AGENDA
COLUMBIA FALLS CITY-COUNTY PLANNING & ZONING BOARD
TUESDAY, AUGUST 11, 2020 BEGINNING AT 6:30 PM
COUNCIL CHAMBERS CITY HALL

**ZONE CHANGE REQUEST
COLUMBIA FALLS AREA ZONING JURISDICTION
RUIS HOLDINGS 540 NUCLEUS AVE LLC - PLANNED UNIT DEVELOPMENT AMENDMENT
CITY OF COLUMBIA FALLS STAFF REPORT # CPUD-20-03
July 28, 2020**

A report to the Columbia Falls City County Planning Board regarding a request for an Amendment to the Planned Unit Development overlay (PUD) on 540 Nucleus Avenue property.

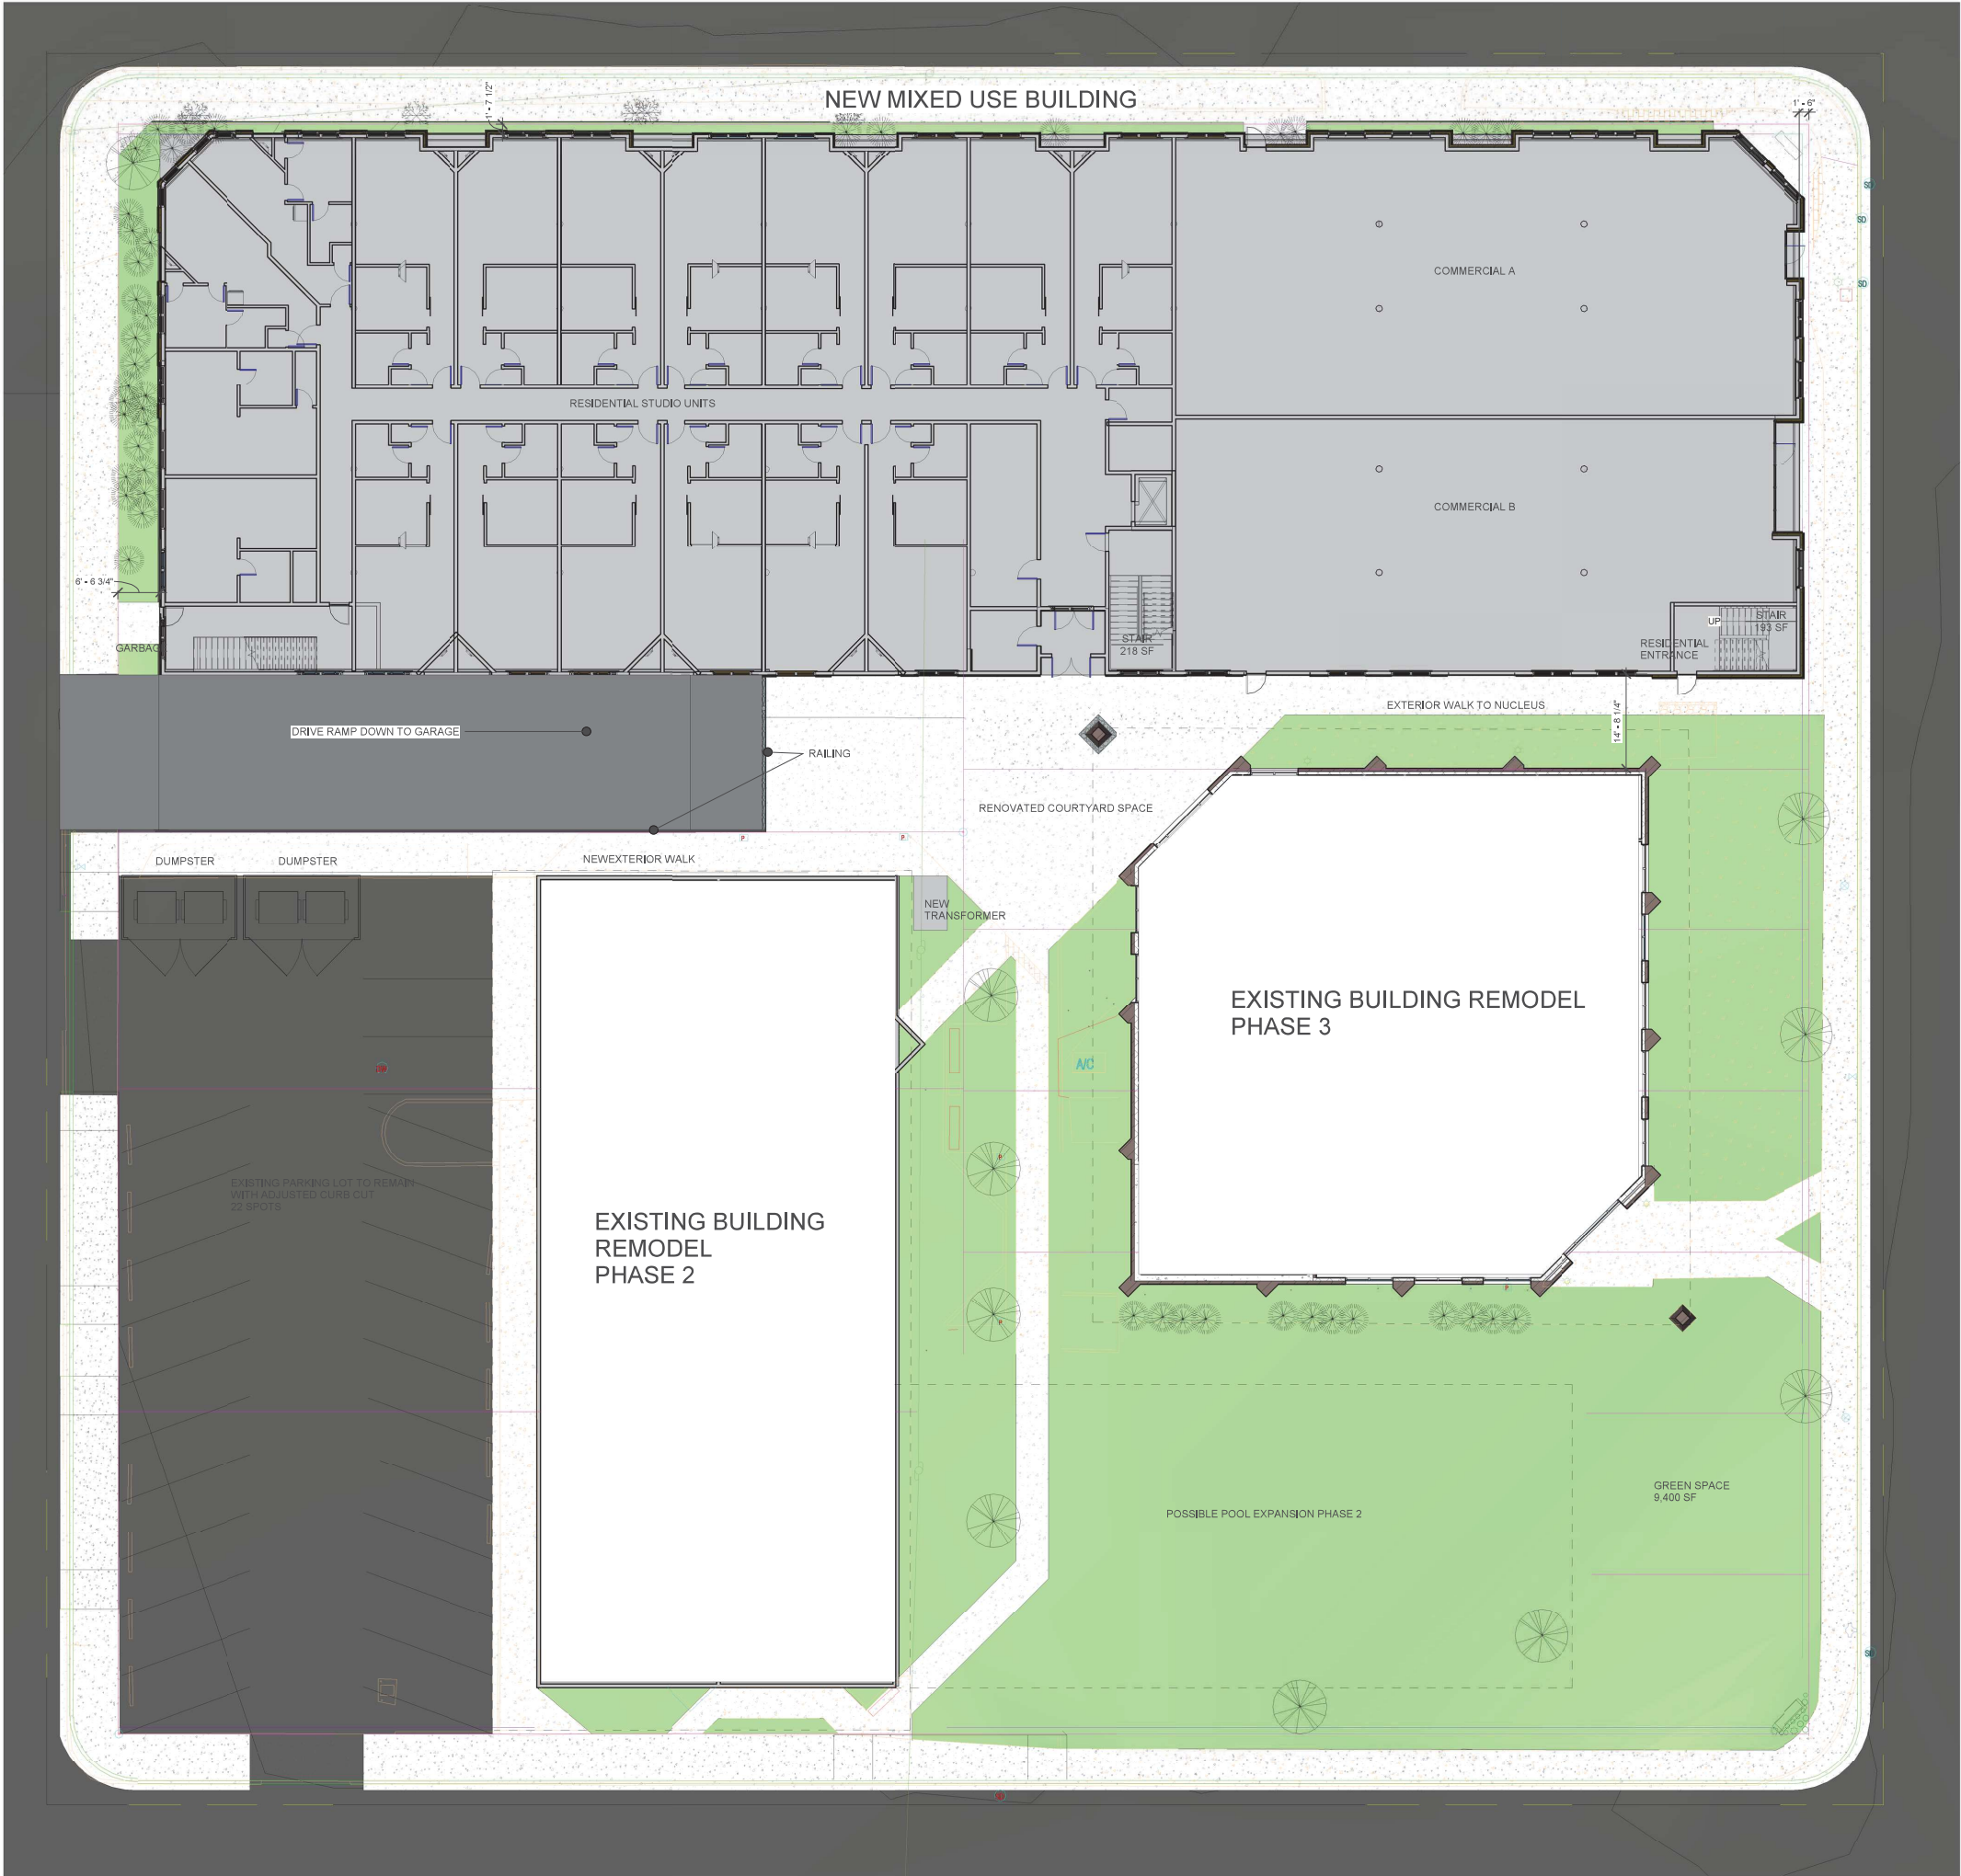
The applicant provided a site plan that lacks snow storage areas. The drainage plan will be reviewed by public works and a snow storage plan will be reviewed at that time.

- A. The applicant's site plat is showing a trash enclosure in the parking surface lot in both Options 1 and 2. The applicant will construct a site obscuring fence with gates around the dumpster site as indicated on the site plan. The applicant shall include plans for the refuse enclosure with the building plans.
- B. The developer is not proposing a loading dock.
- C. No outdoor storage is proposed.

13. The applicant will construct a site obscuring fence with gates around the dumpster site as indicated on the applicant's site plan. The refuse screening shall be included with the building permit plans.

SITE PLAN, NO UNDER BUILDING PARKING

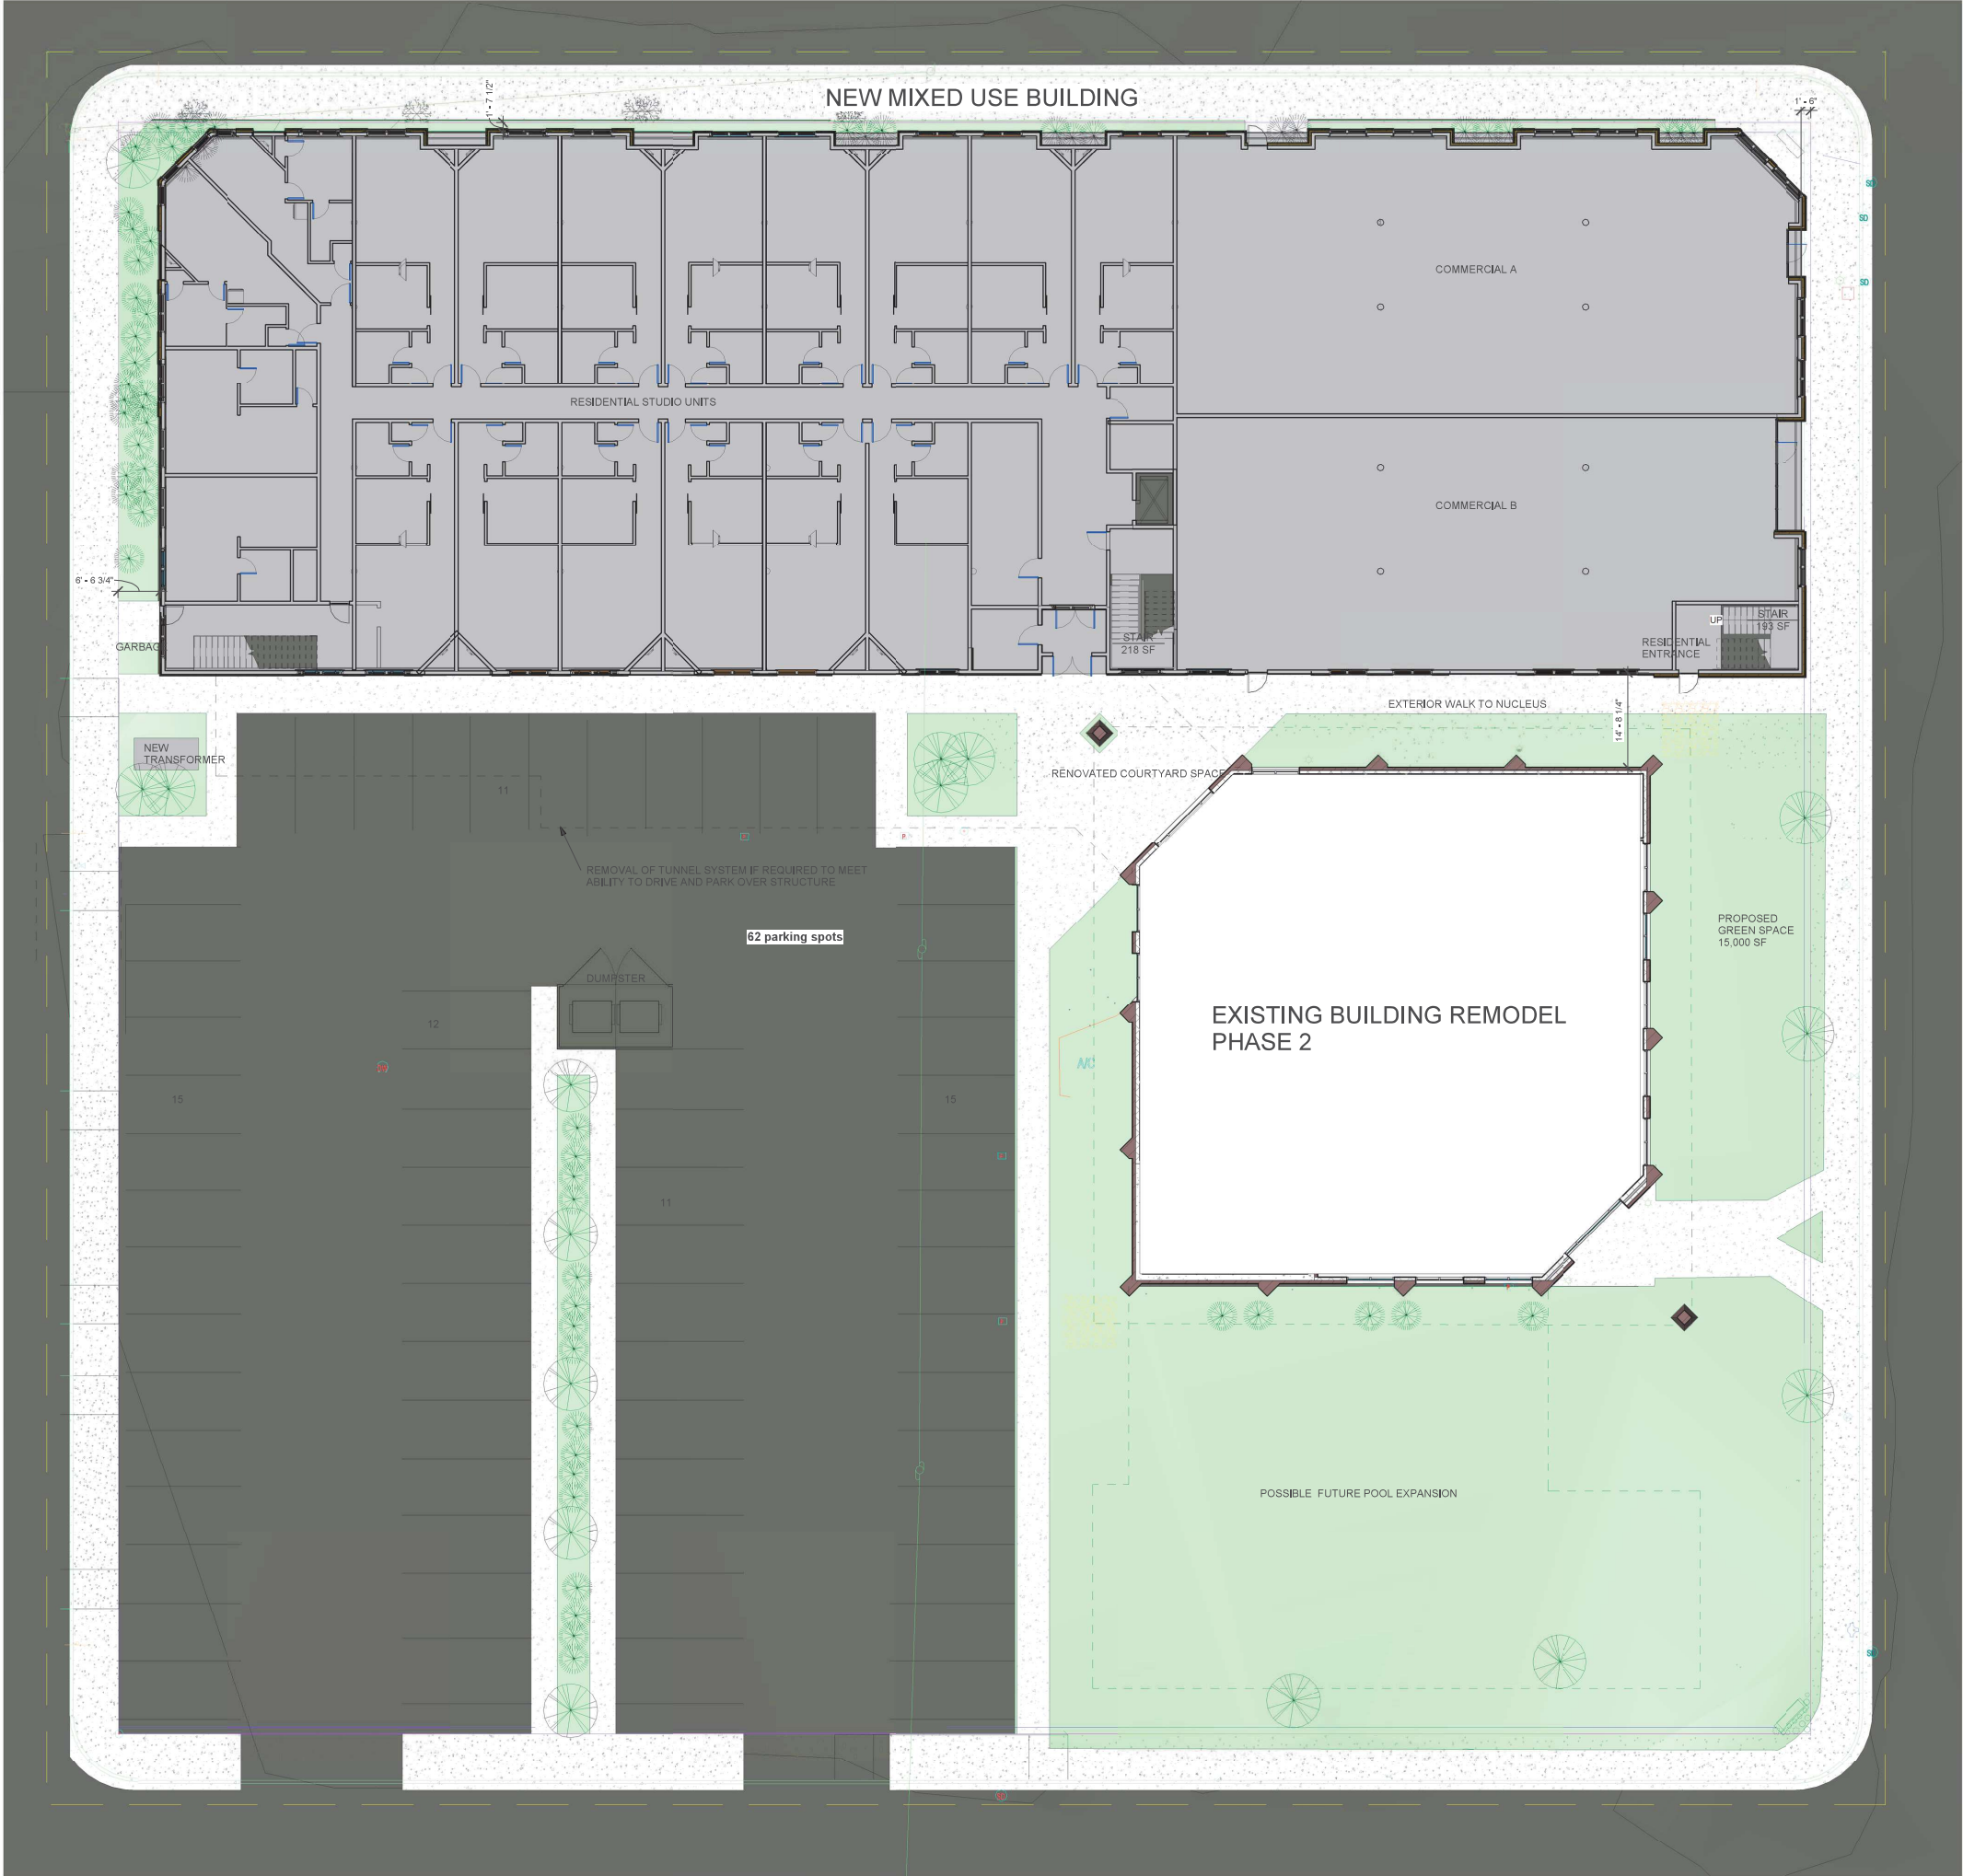
Option 2: The applicant will not construct underground parking but instead will remove the southwest commercial building and reconstruct the surface parking lot to create 62 off-street parking spaces.

With Option 1, the applicant is not changing the parking configuration of the surface parking lot or changing the footprint of the existing building. Therefore this parking area would be “grandfathered” from the parking lot landscaping requirements. However in Option 2 where the southwestern building is removed and the parking lot will need to comply with the landscaping requirements. For example, there will need to be planter strips between the sidewalks along 1st Ave West and 6th Street West and the new parking lot.

4. Prior to the submittal of plans for the building permit, the applicant shall work with the Columbia Falls Fire Chief for approval of the FDC locations, Knox Box location, roof access, and turning radius within the parking lot should the applicant go with Option 2.
